## REVISED - Comments and Responses on the Clay Street at Main Street/Cedar Ravine Realignment and Clay Street Bridge at Hangtown Creek Replacement Project Initial Study/Mitigated Negative Declaration

Clay Street at Main Street/Cedar Ravine Realignment and Clay Street Bridge (25C-0117) at Hangtown Creek Negative Declaration

Subject: Clay Street at Main Street / Cedar Ravine Realignment and Clay Street Bridge (25C-0117) at Hangtown Creek Replacement Project  
 SCH#: 2010092031

Cottonwood Phases 4 & 6, north of Clay Street

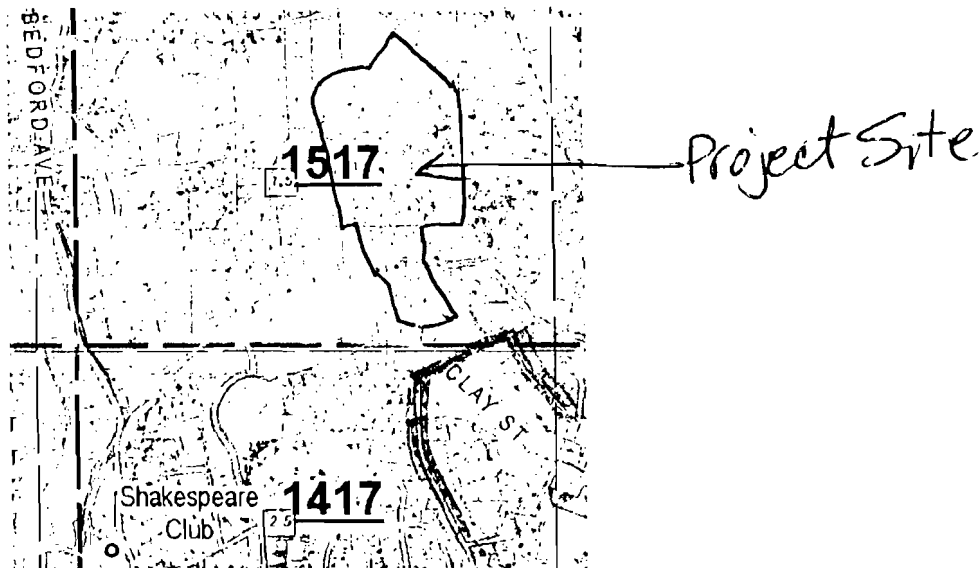
The Cottonwood Park Planned Development Phases 4 & 6 are already in progress involving 39 single-family residential parcels and the completion of the project will most certainly generate additional traffic. The Cottonwood project involves the “continuation of Constellation Drive between Clay Street and Poverty Hill Road/Roddan Court” and “The project also is designed to facilitate a future connection to an undeveloped parcel located to the east.” (Community Development Department Planning Commission Staff Report, Cottonwood Park Planned Development Phases 4 & 6, September 7, 2010.) In addition, the Cottonwood Development Plan includes a propane farm which will cause propane delivery trucks to utilize Clay Street for access. The MND needs to measure and calculate the cumulative impacts that these future residential developments will create, and it has not done so.

The Cottonwood Park Planned Development Phases 4 & 6 are the final phases of a development that began in 1988. The City of Placerville adopted a mitigated negative declaration for Phases 4 & 6 in 2006. Phases 4 and 6 have a circulation system that provides two access points by extending Constellation Drive and connecting Clay Street with Roddan Court and Poverty Hill
